**Moorebank Intermodal Terminal**

Independent Traffic & Transport review of  
the MIC Staged SSD

**NSW Department of Planning &  
Environment**

8 October 2015

Figure 1 Revised Intermodal Terminal Layout Map

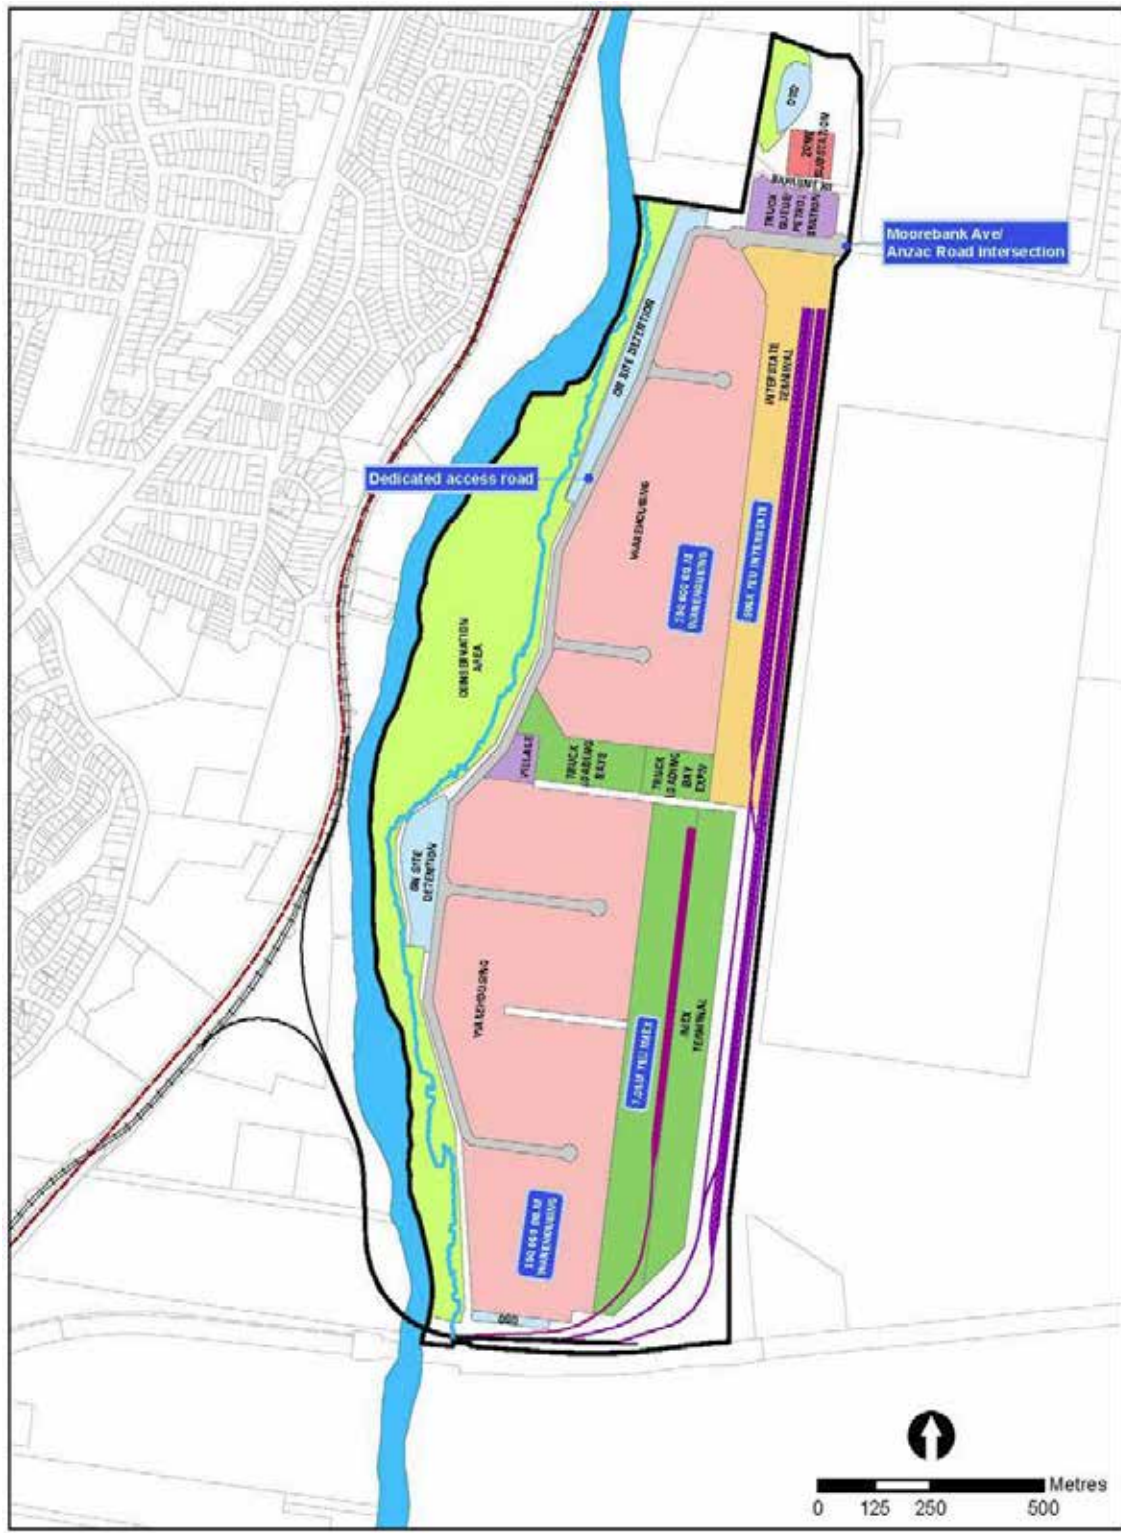
Aurecon raised concerns that changing the previous 5 site entry/exit points outlined in the EIS, to the single entry/exit point only 350m from the M5 on/off ramps, as described in the RtS, presents a significant risk in case of any on-site incidents resulting in delays for entering traffic, and thereby queuing back onto the M5. Similarly, MIC's response to Campbelltown Council that "*In the event of an accident on the M5 Motorway/ Moorebank Avenue north of the terminal, the terminal will need to shut down until the traffic is cleared*" seems to also be a significant operational risk for the Intermodal Terminal. Aurecon recommended that a site operation plan be developed to allow detour of trucks to an alternative access or location in case of major incidents.

With regard to incidents or breakdowns for trucks near the site entry/exit point at Moorebank Avenue/ Anzac Road, MIC's revised layout provides a truck parking and holding area just inside the site entry point which can accommodate up to 25 trucks. This can serve as emergency truck parking in the event of a major delay affecting site entry or exit.

Figure 2 Extent of SIDRA 6 modelling area

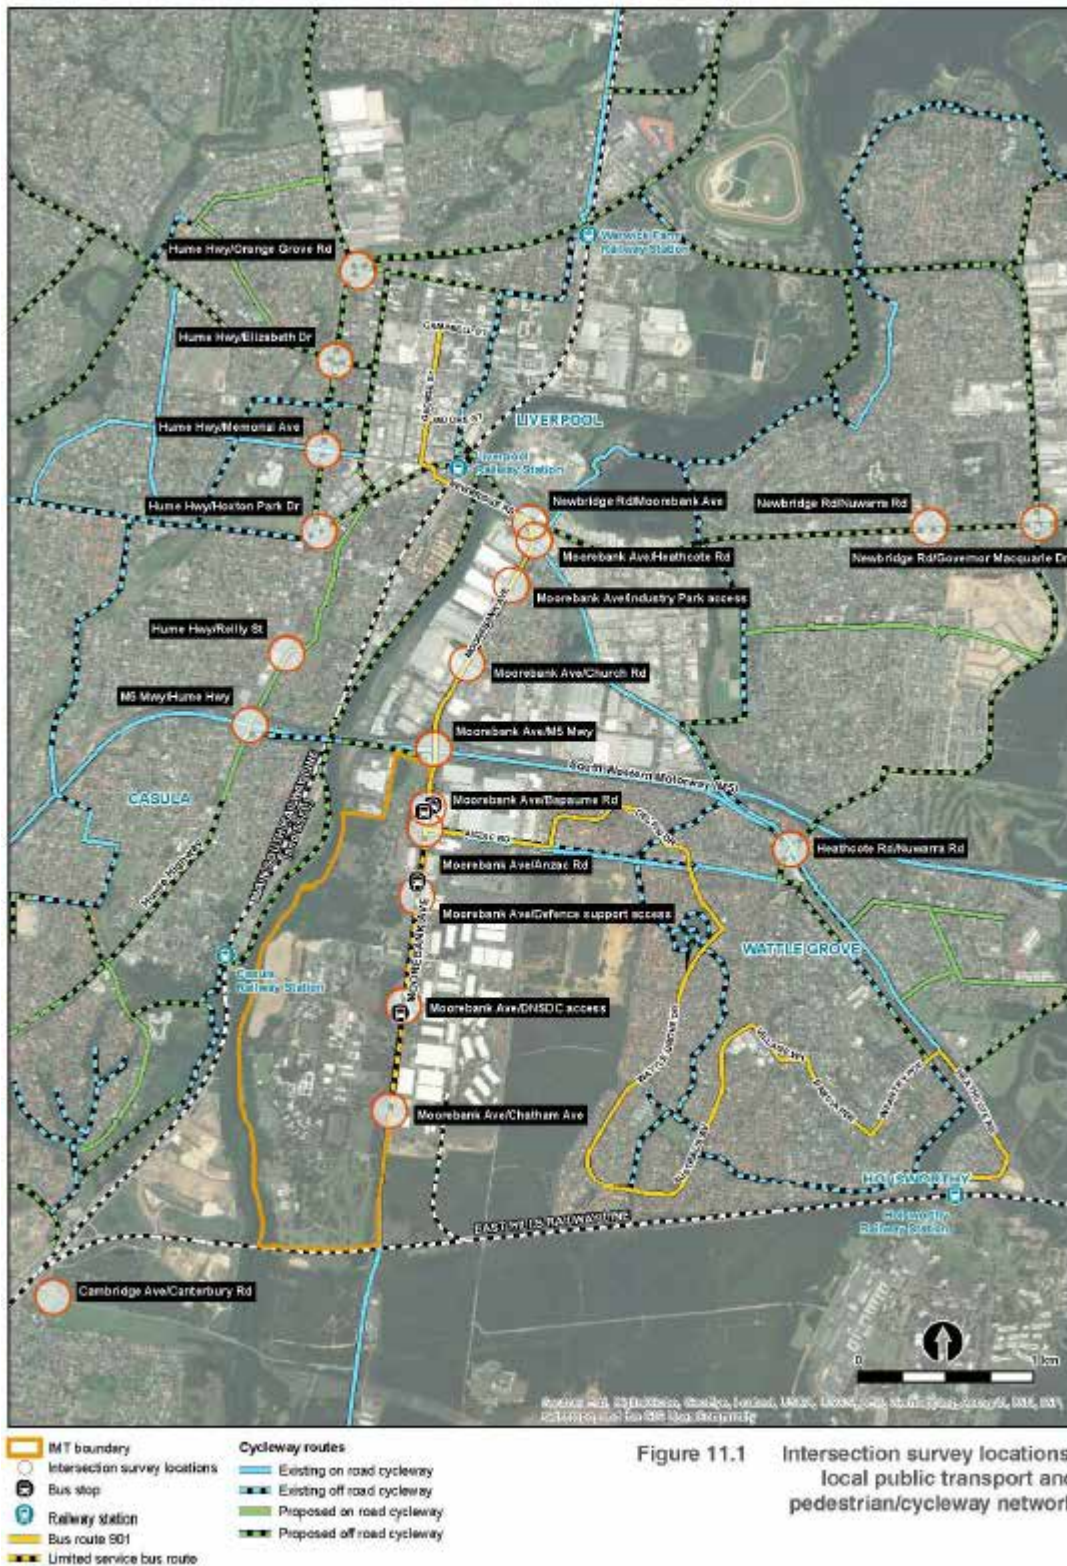
All previous SIDRA traffic modelling indicates that the existing and forecast future level of background traffic is likely to result in LoS D, E, or F on most of the major intersections in the vicinity of the MIC Intermodal Terminal, and that even the mitigation measures proposed (such as intersection expansions, extending traffic turn bay lengths) provide only a very marginal improvement for the likely cost and traffic disruption caused in providing them.

Hence, it is considered that mitigation measures cannot be just about 'supply-side' measures (as it is likely that any infrastructure expansion that may provide significant improvement in LoS will come at considerable cost) but will also need to consider 'demand-side' measures (such as dedicated freight and bus/HOV lanes, traffic signal phasing and timings, ITS, peak spreading).

§ Aurecon recommends that the modelled scenarios include options that could reduce background traffic flows, such as providing Bus Transitway-style facilities on the M5 and M7, and/or increase the vehicle occupancy with a combined bus/HOV lane or bus/HOV/freight lane; traffic signal phasing and timings, ITS, and peak spreading.
